Riverview Planning Advisory Committee
STAFF REPORT
Conditional Use

Subject : Conditional Use - Allan Street

File number: 20-386

Meeting Date: Wednesday, May 13, 2020

SITE PLAN

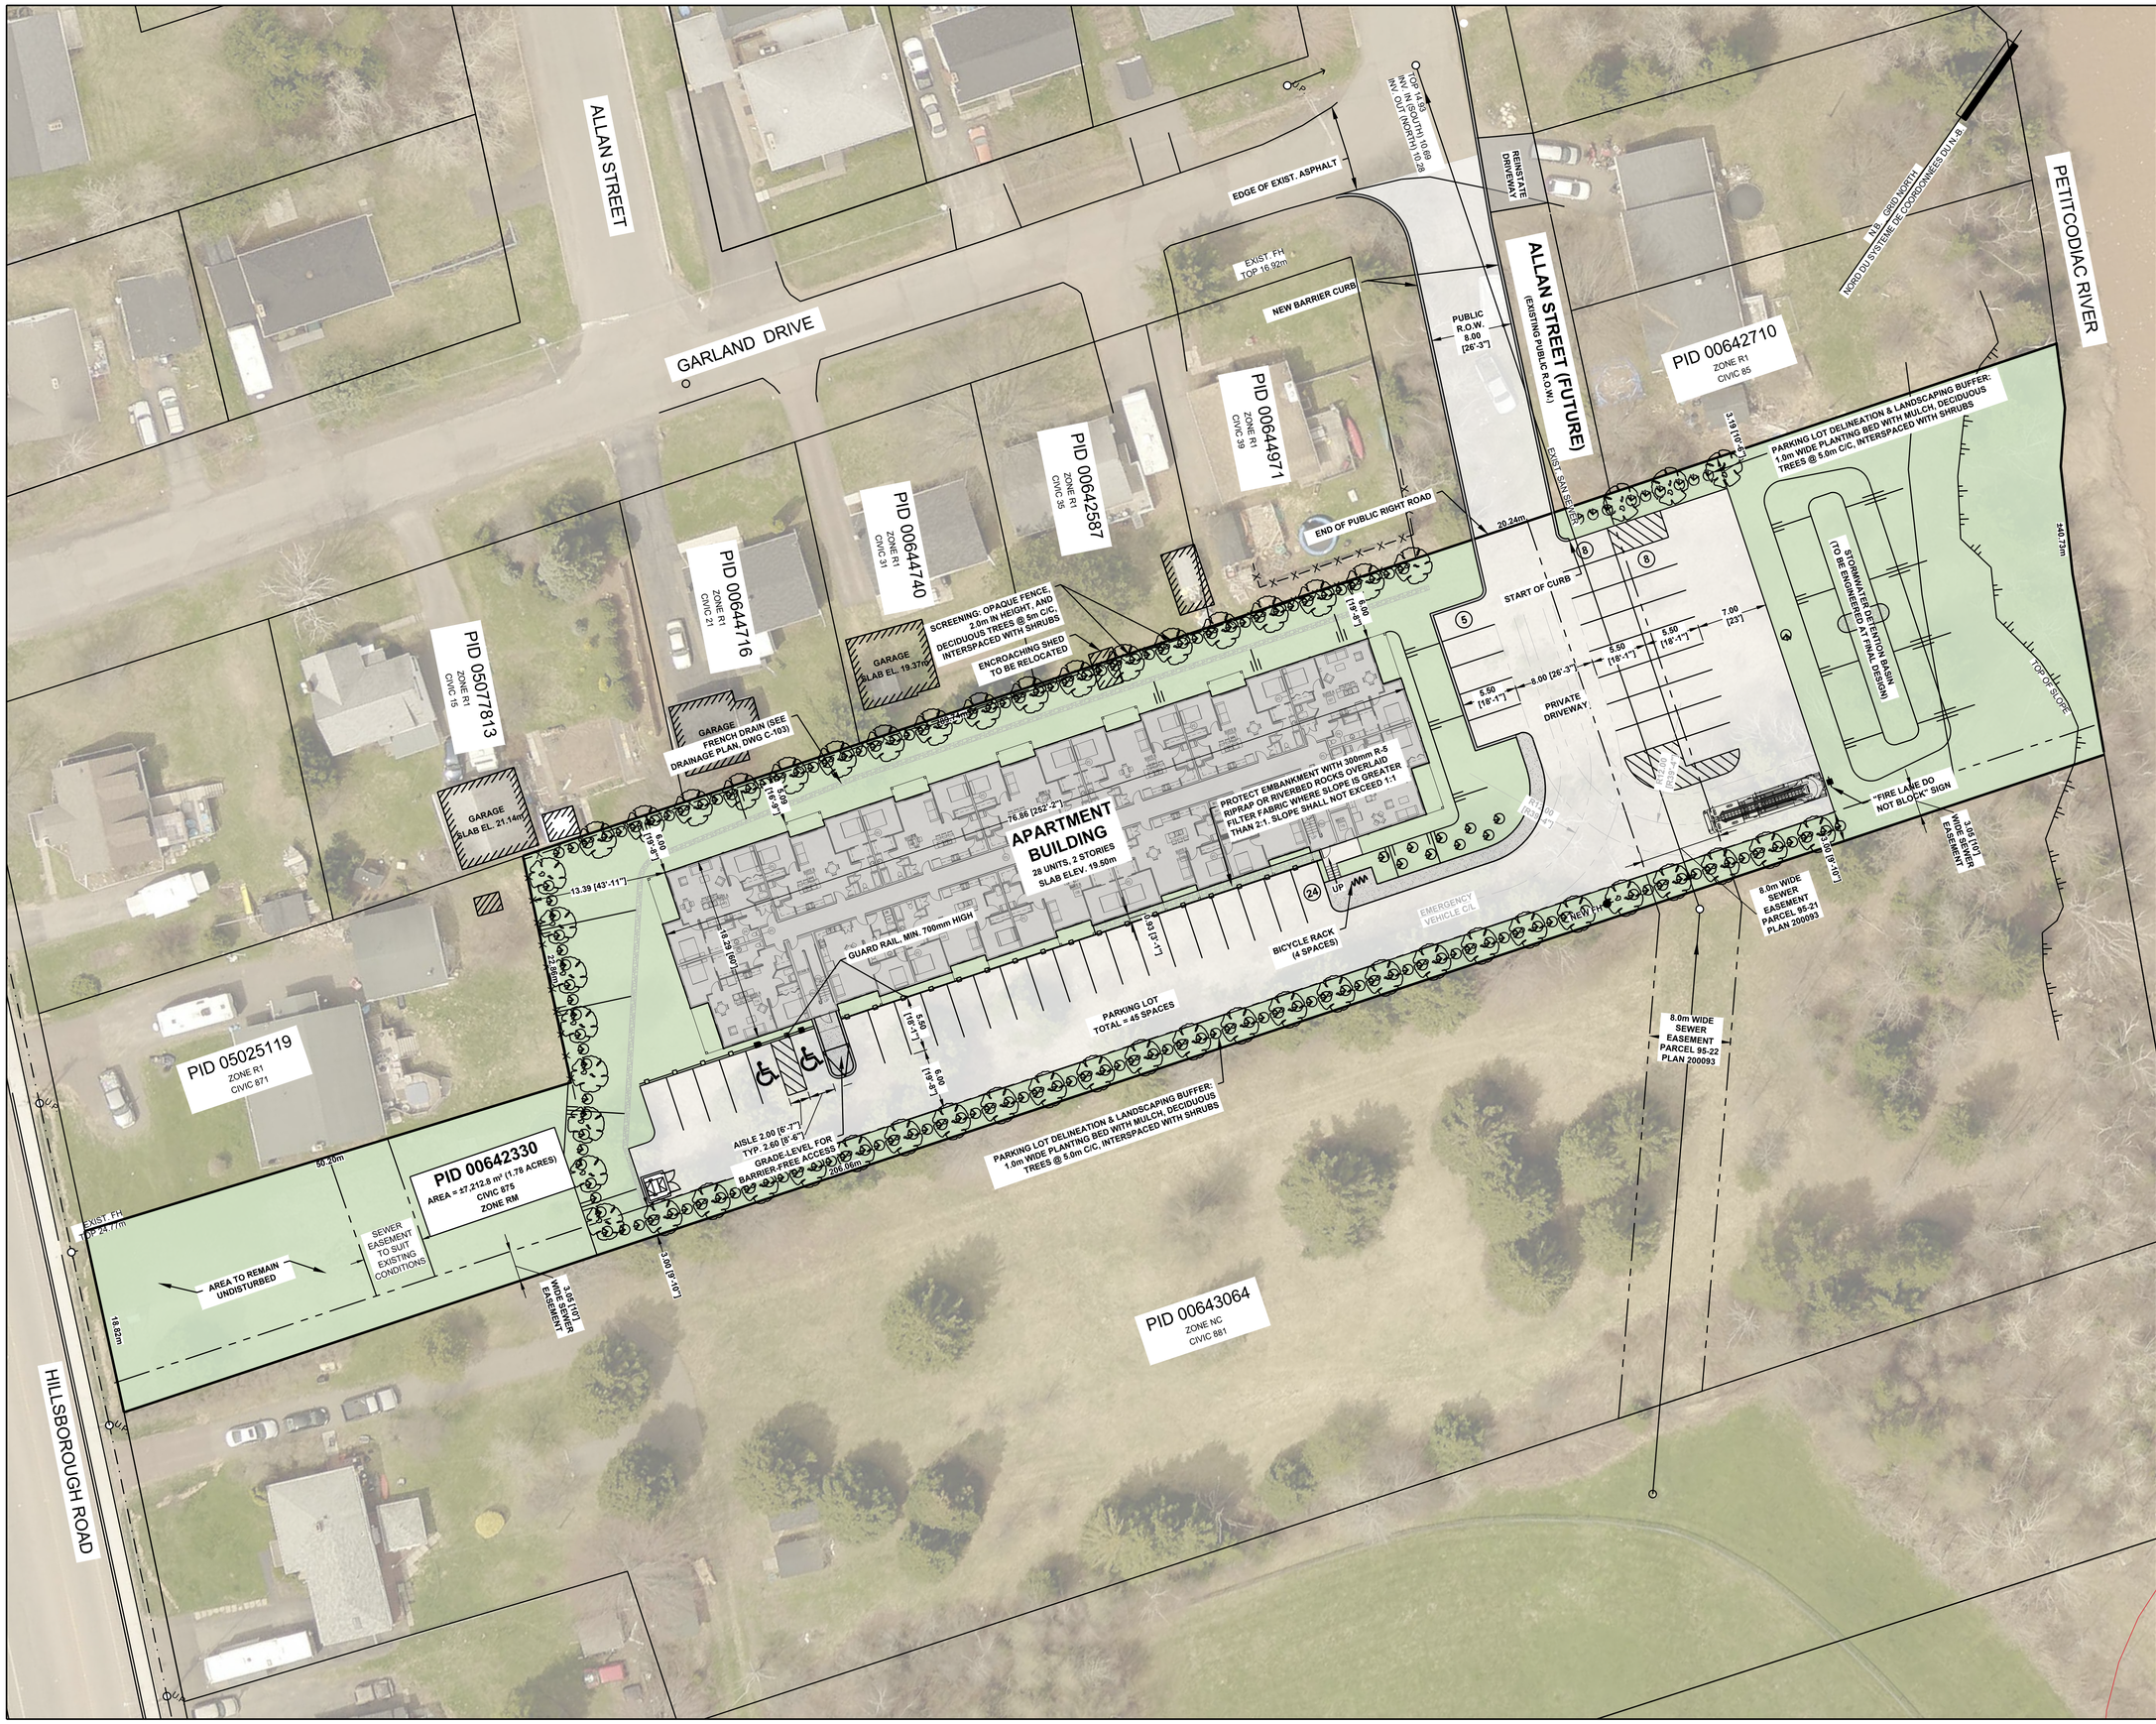
The lot has frontage on Hillsborough Road with a second frontage on Allan Street. The initial site plan proposed to use Hillsborough Road as the main access point. However, due to a blind crest, it was impossible to meet sight distance requirements for a main access on Hillsborough Road. An access here would be limited to a “right-in, right-out” design, which would require a second access on Allan Street. The current proposal has eliminated the Hillsborough Road access in favour of a single entry on Allan Street.

A 6 metre wide landscaping buffer comprised of trees, shrubs, and an opaque fence is required between the building and adjacent R1 zones. Based on the plans submitted, this requirement can be met and still accommodate the proposed drainage system. However, the proposed building design includes balconies on both sides of the building. To the north, these balconies would encroach 0.9 m into the landscape buffer. The Zoning By-law allows balconies to encroach 2 metres into a required yard (ie the building setback line), and states that the landscape buffer shall not be used for parking, garbage storage or public utilities. However, it is silent on balcony encroachments into landscape buffers. Based on this gray area, staff felt it was prudent to treat this request as a variance from the By-law requirements. Considering that the balconies would be permitted as-proposed within the building setback, and that the landscaping requirements can still be met, staff considers this request to be reasonable and within the general intent of the Municipal Plan and Zoning By-law.

2) that no snow storage be permitted within the emergency vehicle turnaround, and that a “No Parking - Fire Lane” sign be erected in the area reserved for the emergency vehicle turnaround as shown on the site plan dated April 22, 2020

1) APPROVE the requested variance to permit balconies to encroach 0.9 metres within a landscape buffer because the request is reasonable and within the general intent of the Municipal Plan and Zoning By-law: and

2) APPROVE the request to waive the requirement for a public entrance facing a street because due to site conditions the requirement can not be met
